UNITED STATES PATENT AND TRADEMARK OFFICE

10/554,172

Office Action Summary	Application No. 10/554,172	Applicant(s) MUGICA MIGUEL ET AL.	
	Examiner TAM NGUYEN	Art Unit 3764

DETAILED ACTION

FIG. 10

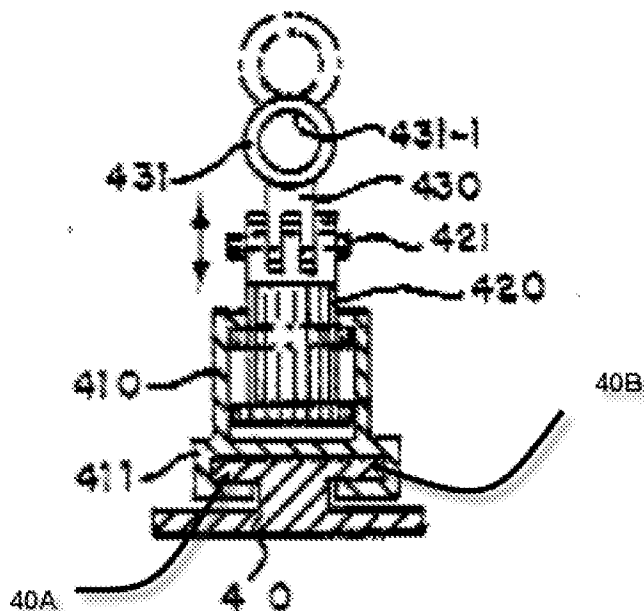
6. As to claims 1, 3 and 8, Kim discloses a training bench having a framework that includes two or more longitudinal bars (200R,200L), rotational rollers or a belt (250) located between the bars and a central support, that can be connected to a pedal set casing of a bicycle, that: includes a platform (411) connected to the framework with transverse bars or guides (40A,40B) on which the platform can move in a free or regulated manner and an anchoring system (410,430) serving as a holding base for holding a vertical column (420) and providing a support means for the frame of a bicycle on a free end of the vertical column and the anchoring system acting as an absorption member to control the movement of the bicycle relative to the platform and framework (see Fig. 10 below and Figs. 9 & 11). Kim does not disclose that the anchoring system is elastically deformable. Lim et al. disclose an exercise device having a deformable anchoring system for supporting a bicycle wherein the anchoring system includes a pair of elastically deformable springs (180) (see Fig. 1). At the time of the invention, it would have been obvious to a person of ordinary skill in the art to combine Lim's springs with

Kim's anchoring system to provide a means for biasing the vertical column back to center following side to side swaying motion due to pedaling of a bicycle on the bench during exercise to enhance the outdoor riding simulation experience.

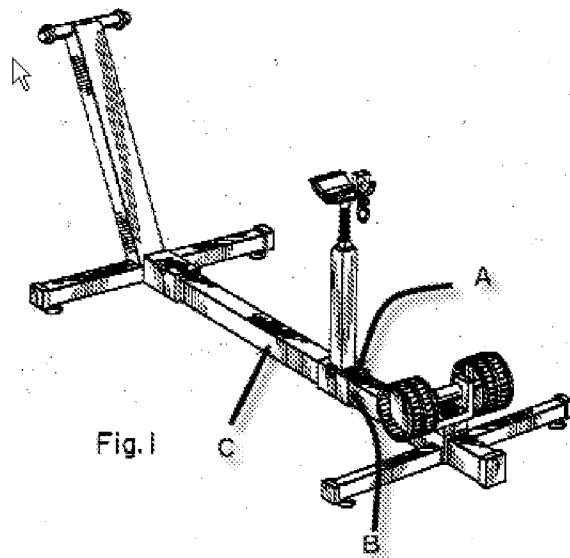
7. As to claim 2, Kim and Lim disclose a modified training bench as described above. Kim does not disclose that the platform has one or more parallel through bores for receiving transverse bars to allow the platform to slide therein. Bryne discloses a bicycle trainer having a platform (A) with a through bore (B) for receiving a bar (C) to allow the platform to slide on the bar (see Fig. 1 below). At the time of the invention, it would have been obvious to a person of ordinary skill in the art to substitute Kim's platform and transverse bars with Bryne's platform having a bore to further stabilize the

coupling means between the bicycle and the training bench since the bore would fully encircle the transverse bar to further strengthen the connection between the bar and the platform.
